Inspection Report
Vintage Eastside
688 East 16th Avenue

Re: Vintage East Side, Strata Plan LMS 3868
688 East 16th Avenue, Vancouver B.C.
- 1 Year Deficiency Review - Deficiency List

Re: Strata Plan LMS 3866, Vintage East Side
688 East 16th Avenue, Vancouver, B.C.
- 1 Year Deficiency Review

Photo # 18

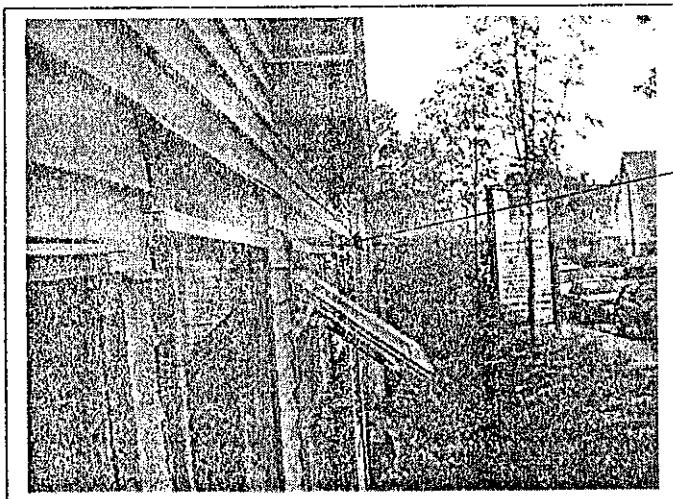
- .1 In general, the framing, PVC material, hardware, glass, glazing stops and gasketing were in good condition. Our specific observations and comments are as follows:
- .2 Framing - Noticeable and sometimes excessive deformations of extruded PVC framing were observed at several locations. The following was recorded:
 - .1 Noticeable deformation of sill profile at windows with the coupling mullion, may be related missing proper support for weight of glass unit or shims missing at the vertical coupler itself.
 - .2 Noticeable deformation of head flashing, may be related to deflection of wall / floor structure above the windows. Further movements, ultimately,

Typical deformation of head flashing.

Photo # 23

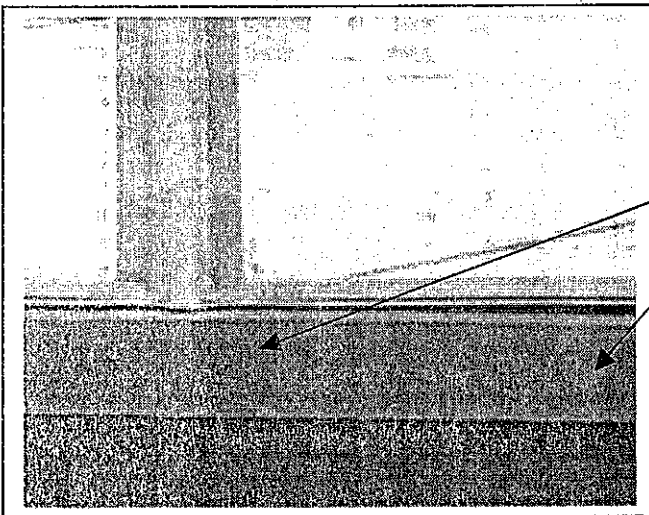
Noticeable deformations of sill profile.
